## **Proposal for Supplement 1 to the 04 series of amendment to UN Regulation No. 127 (Pedestrian safety)**

### **Submitted by the Working Party on Passive Safety \***

The text reproduced below was adopted by the Working Party on Passive Safety (GRSP) at its seventy-second session (ECE/TRANS/WP.29/GRSP/72, para. 26). It is based on ECE/TRANS/WP.29/GRSP/2022/19 as amended by annex IV to the report. It is submitted to the World Forum for Harmonization of Vehicle Regulations (WP.29) and to the Administrative Committee (AC.1) for consideration at their June 2023 sessions.

Figure 12  
**Windscreen test area**

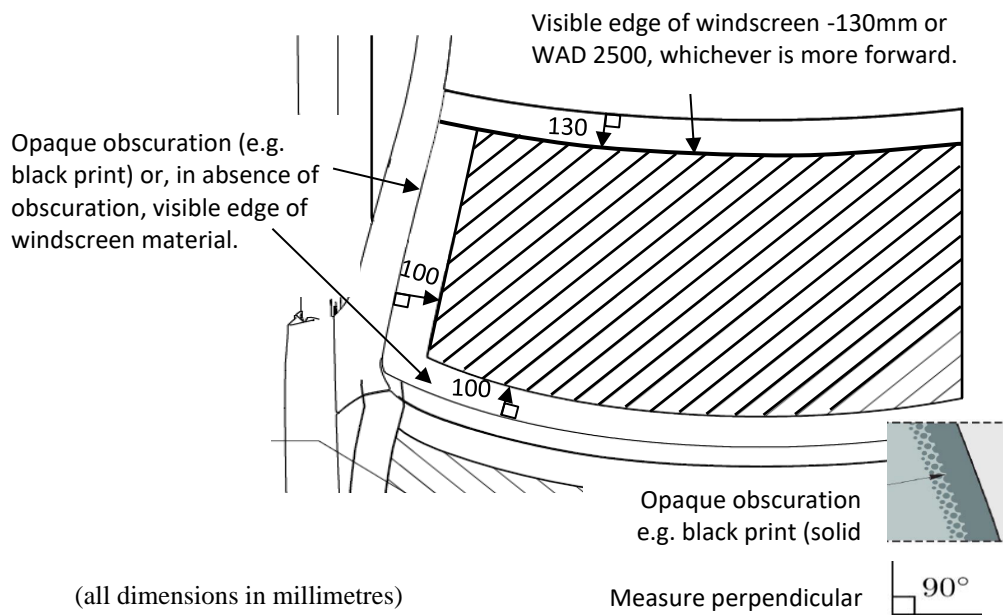
*Paragraph 2.44.*, amend to read and insert Figures 12 and 13:

"2.44. "Windscreen test area" is an area on the outer surface of the windscreen. It is bound (see figure 12):

- (a) In the front, by a line 100 mm rearward to the opaque obscuration of the windscreen. In case of absence of the opaque obscuration, the line is measured from the front visible edge of the windscreen material.
- (b) In the rear, by a WAD 2,500 or a line 130 mm forward to the rear visible edge of the windscreen material, whichever is more forward at a given lateral position.
- (c) At each side, by a line 100 mm inside the opaque obscuration of the windscreen. In case of absence of the opaque obscuration, the line is measured from the side visible edge of the windscreen material.

For (a) and (c): the distances of 100 mm are to be measured with a flexible tape held tautly along the outer surface of the vehicle at an angle of 90° to the tangent line to the opaque obscuration limit or in case of absence of the opaque obscuration, from the visible edge respectively.

For (b): the distances of 130 mm is to be measured with a flexible tape held tautly along the outer surface of the vehicle at an angle of 90 ° to the tangent line to the rear visible edge of the windscreen.

Figure 13  
**Upper corner definition with "shortest distance"**

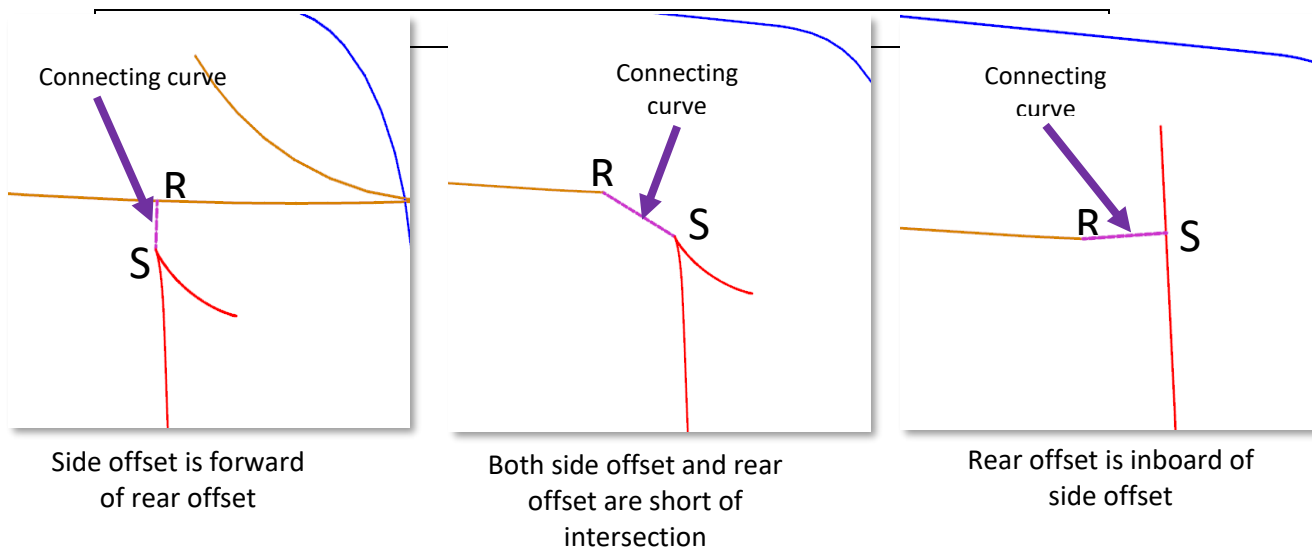
Depending on the geometry, in case there is no intersection between (b) and (c), resulting in an open test area, then the marking shall be modified using the shortest distance to close the open test area (see figure 13).

Figure 14

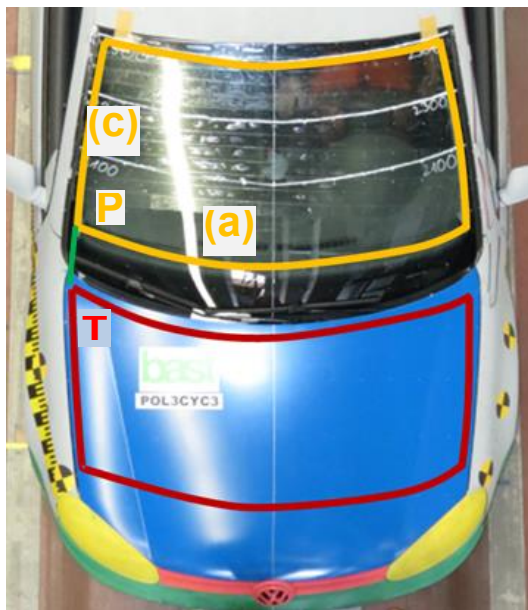
Paragraph 2.45., insert Figures 14 and 15 and amend to read:

At each side, the cowl monitoring area is bound by the TP line (see figure 14), where:

- (a) the "T point" is the rear corner of the bonnet top test area; and
- (b) the "P corner point" is the lower corner of the windscreen test area; using a flexible tape held tautly from point T to P.

Figure 15

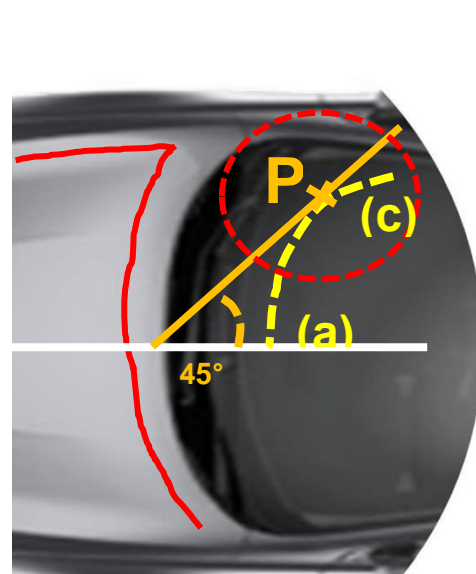
Particular case, if no unique "P point" corner

If there is no unique "P point" where the lines defined in 2.44 (a) and (c) intersect, then the "P point" is defined by the first contact of a vertical plane intersecting the vertical longitudinal vehicle center-plane at an angle of 45° with the (a)-(c) transition of the windscreen test area boundary, as shown in Figure 15.

Figure 16

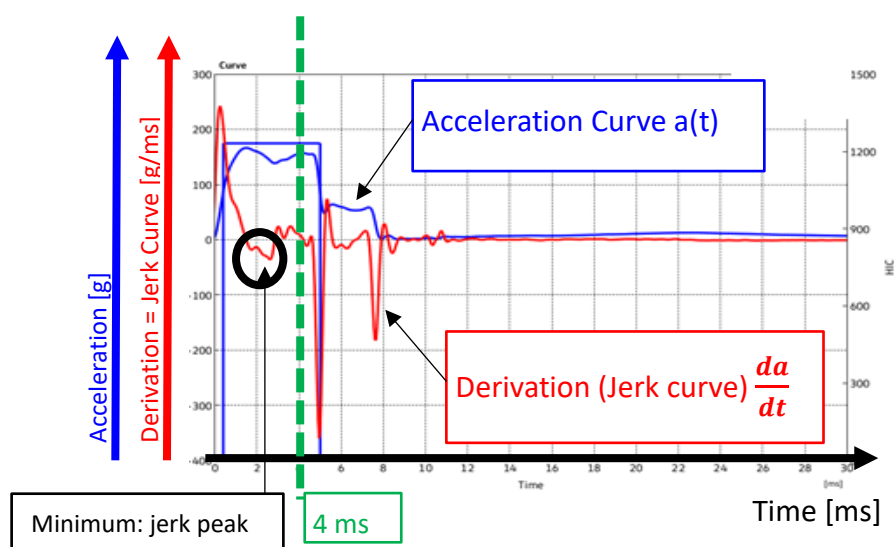
Paragraph 2.48., insert Figure 16 and amend to read:

"2.48. "Atypical windscreen fracture behaviour" is where the headform to windscreen impact results in at least one of the following cases:

- (a) The absolute value of the minimum value of the derivation of the headform acceleration versus time is less than 180 g/ms within the first 4 ms after the initial contact of the headform to the windscreen, as shown in Figure 16; or

$$\left| \min \left( \frac{da}{dt} \right) \right| < 180 \text{g/ms, for } 0 < t < 4 \text{ms}$$
